NEW OIL TANK MOUNTING BRACKETS

NEW Mounting kit 135-903-00020

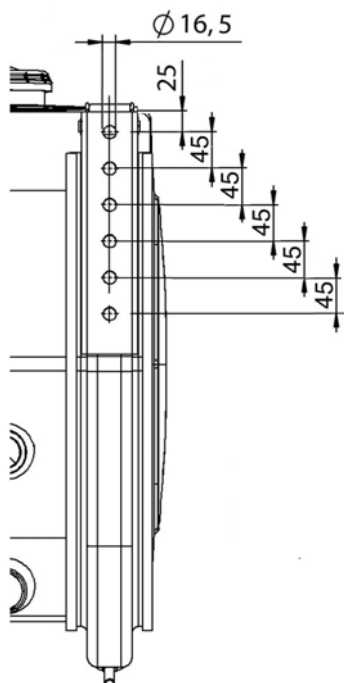
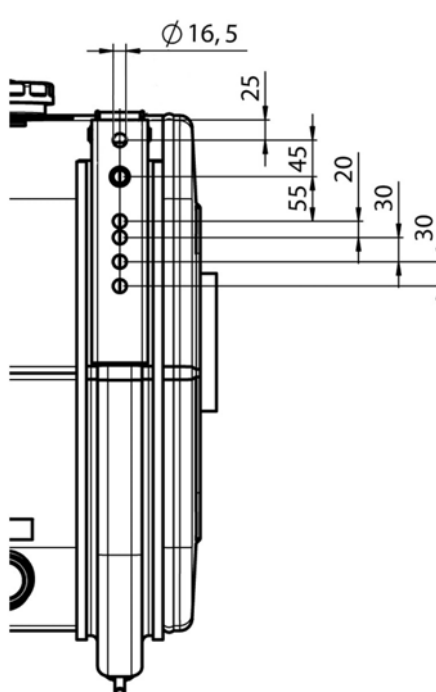
We have introduced a new hole pattern on our mounting brackets for oil tanks in order to cover the different distance between the holes across the various chassis available on the market. Thanks to this new layout it is now easier to fix the brackets to the chassis and it is possible, in some case, to use up to 3 fixing holes each bracket.
